SERVICE DIRECTIVE BULLETIN NO. T-036  
Revision 1

1.    SUBJECT:    Drive System Flex Packs

2.    MODEL:        TH-28, 480, and 480B

**Figure 1.**

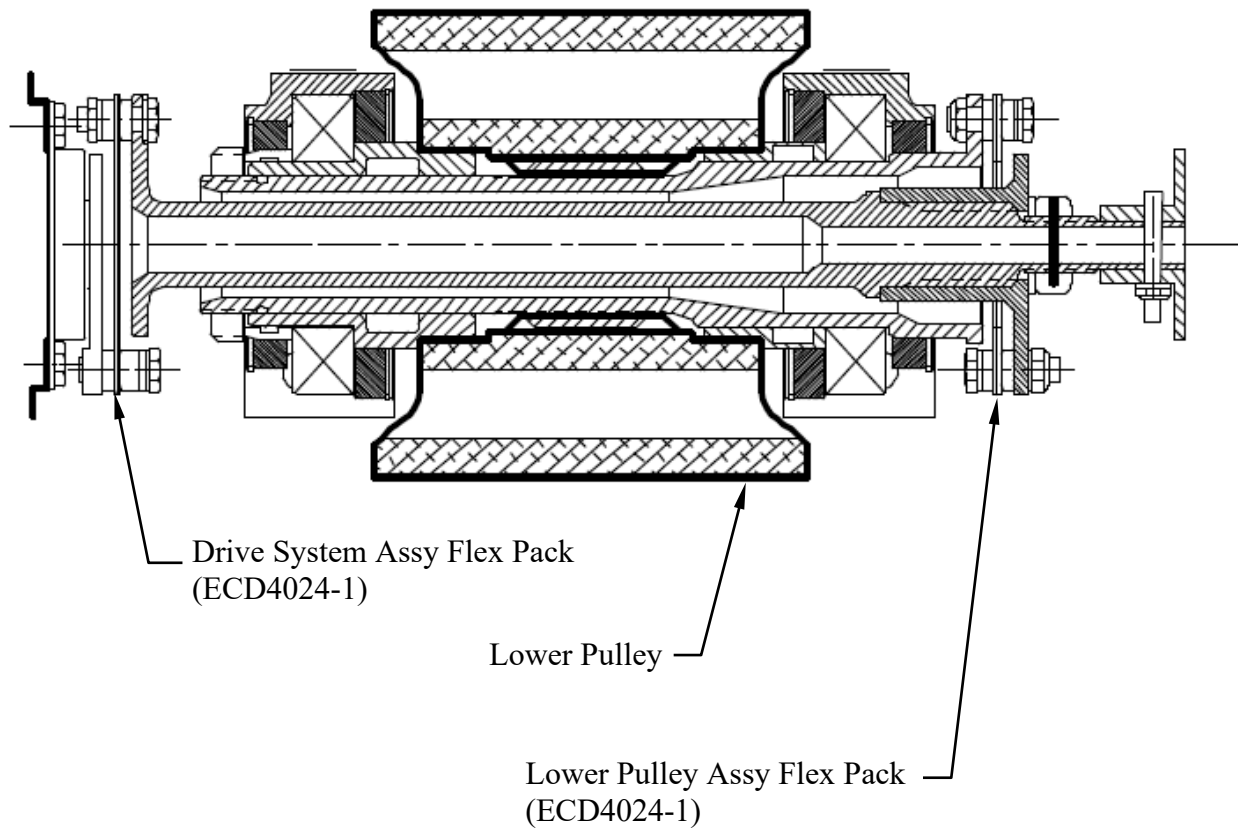
- A. Count the number of elements in each flex pack. There are two flex packs: one on the drive system assembly (forward) and the second is on the lower pulley assembly (aft). Refer to Figure 1. Each flex pack must contain eight (8) elements.

3) Fabricate a gage having a 0.110" wide slotted opening. Align the slot of the gage with the edge of the flex pack. If the flex pack fits in the slot, the pack contains fewer than eight elements. If the flex pack does not fit in the slot, the flex pack contains eight elements

- B. If there are eight elements per flex pack, no further action is required.
- C. If a flex pack contains fewer than eight elements, the flex pack must be removed and replaced in accordance with paragraph 5.2.
- D. Contact Enstrom Product Support with the results of the flex pack inspections.
